United States Patent and Trademark Office

APPLICATION NO.	FILING DATE	FIRST NAMED INVENTOR	ATTORNEY DOCKET NO.	CONFIRMATION NO.		
10/650,932	08/28/2003	Thomas J. Baric	2802-455-002	8065		
7	7590 08/05/2005	EXAMINER				
Christopher H. Hunter PARKER-HANNIFIN CORPORATION			AYRES, TIMOTHY MICHAEL			
6035 Parkland		ART UNIT	PAPER NUMBER			
Cleveland, OH 44124-4141			3637			
		DATE MAILED: 08/05/2005

DETAILED ACTION

This is a first office action on the merits of application SN 10/650,932.

Yasui '935 Figure 1

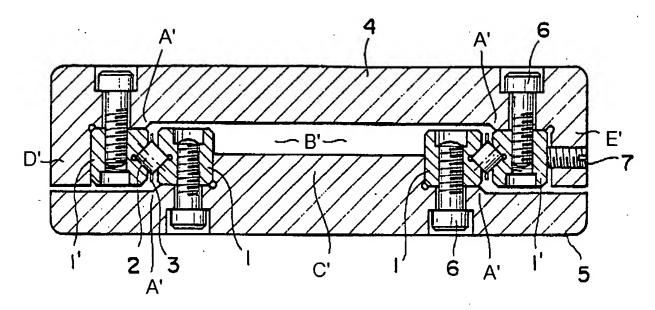
- 8. Claims 1-19 are rejected under 35 U.S.C. 103(a) as being unpatentable over U.S. Patent 4,697,935 to Yasui in view of U.S. Patent 5,328,269 to Mutolo. Yasui '935 discloses a linear table comprising a base (5) with an essentially flat lateral mounting surface. A slide plate (4) also with an essentially flat lateral mounting surface. The slide

plate (4) being mounted to the base (5) such that the mounting surface of the base is in opposed relation to the mounting surface of the slide plate as shown in Figure 1 below.

- 9. A pair of bearing assemblies (1, 1', 2, 3, 6) interposed between the base (5) and the slide p[late (4), with each bearing assembly including a pair of bearing ways (1,1') and a rolling element (2,3) between the bearing ways, with one bearing way (1) from each bearing assembly fixedly secured to the mounting surface of the base (5). The other bearing way (1') of each bearing assembly fixedly secured to the mounting surface of the slide plate. A preload screw (7) is used to give the bearing ways a predetermined preload.

- 11. Regarding claim 3, the base (5) and the slide plate (4) each include short locating ribs (A') projecting outwardly from the flat surfaces of the base (5) and the slide plate (4), respectively, the ribs (A') having a flat surface, and the bearing ways (1,1') each having a corresponding flat surface located against the flat surface of the ribs (A'), the ribs spacing the bearing ways from the opposed surface of the respective base (5) or slide plate (4) as best seen in figure 1 below.

13. Regarding claim 7, the precision parallel device (C', D', E') is located in engaging relation to one of the bearing ways of each bearing assembly. For claim 9 the precision parallel device (C') is located between the inner bearing ways (1). For claim 10 the precision parallel device (D', E') is located on the outside of the outer bearing ways (1').

- 14. Yasui '935 does not disclose expressly that the bearing ways are only supported against the flat lateral mounting surface of the base or slide plate and that the linear table is without integral locating and preload means.
- 15. Mutolo '269 teaches a linear bearing that uses pneumatic cylinders (66,68) to create a preload through a tool member (70,72) while using a force gauge (74) to find the minimum resistance on the slide plate (18). Once the minimum resistance is meet, then the structure is fastened together with either adhesive or a fastener (50).

- 17. Neither Yasui '935 nor Mutolo '269 expressly disclose that the bearing ways are only supported by lateral surfaces. It would be obvious that the screws (6) in conjunction with the lateral surfaces can support the preload and elements (C', D', and E') are used with the preload screw (7) and once the screws (6) are securely tightened the elements (C', D, and E') are unnecessary to maintain the preload.
